Safety Recall Action Notice 579 Issue 4 - 07.2020

Subject: Front Brake Pads			
Bulletin Number	Models Affected	VIN Range	Markets Affected
579	Tiger 1200 XR	From VIN 800262 to VIN AC0327	All Markets Except China
	Tiger 1200 XR _x		
	Tiger 1200 XC _x		
	Tiger 1200 XRT		
	Tiger 1200 XCA		
	Tiger 1200 XR _x (Low Ride Height)		
	Tiger 1200 - Alpine		
	Tiger 1200 - Desert		
	Street Triple RS	From VIN 800262 to VIN AC0327 Plus Japan Markets Only - See Appendix B	
	Speed Triple RS Speed Triple S	From VIN 800262 to VIN AC5827

Calipers

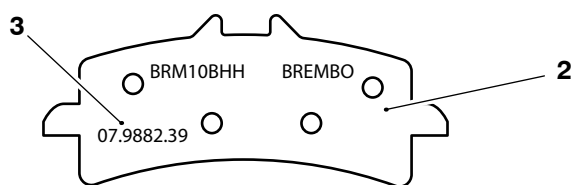
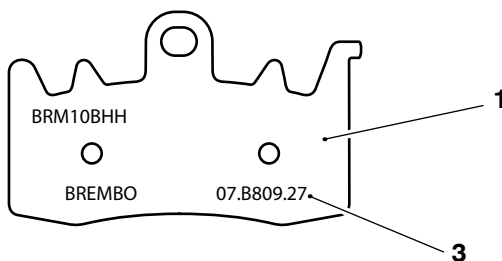
Models	Old (defective) Triumph Brake Caliper Part Numbers	New (remedy) Triumph Brake Caliper Part Numbers
Tiger 1200 models listed above	T2022460 T2022470	T2022970 T2022980
Speed Triple RS and Speed Triple S	T2023530 T2023540	T2023550 T2023560
Street Triple RS	T2021558 T2021559	T2023260 T2023270

1. Tiger 1200 new remedy brake pad
2. Speed Triple and Street Triple new remedy brake pad
3. Brembo part numbers

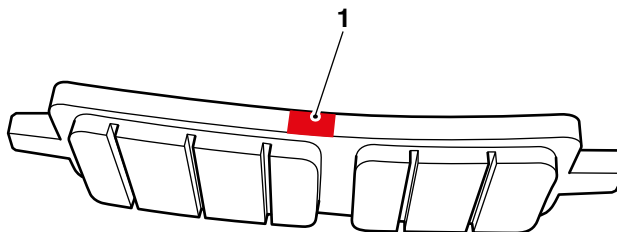
Remedy brake pads include a red paint identifying mark as shown in the following illustration.

1. Red paint identifying mark
